#### Working Party on the Transport of Perishable Foodstuffs

### Proposal to add requirements for the measurement of K values of fixed walls for multi-compartment equipment

Transmitted by the Government of France

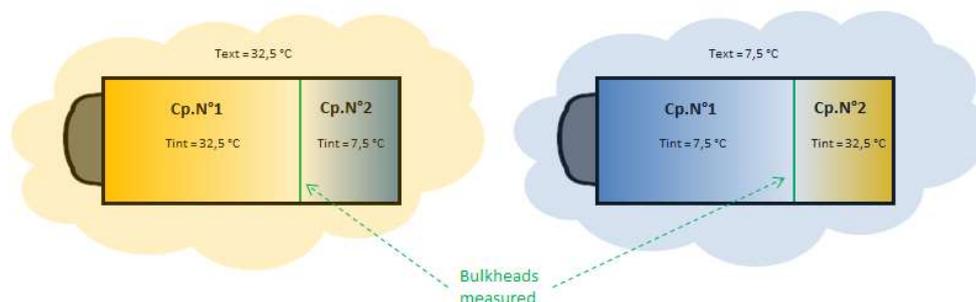
7. By adding an amendment to paragraph 7.3.7, it introduces adjustments required to meet the need to:

- adapt the test method for multi-temperature mechanical refrigeration units in paragraph 7.2 so as to include the multiple evaporator refrigeration units thus included in ATP; and
- encourage manufacturers to propose better solutions for compartmentalized transport units meeting ATP requirements.

The methodology is based on:

- establishment of a controlled heat flux through a removable or fixed internal dividing wall whose K coefficient is to be determined;
- cancellation of heat fluxes from all other sides, be they internal or external, if they are not part of the removable or fixed internal dividing wall whose value is being determined.

The two examples below explain the method for different configurations:

Where “Cp. No.X” means compartment number X.
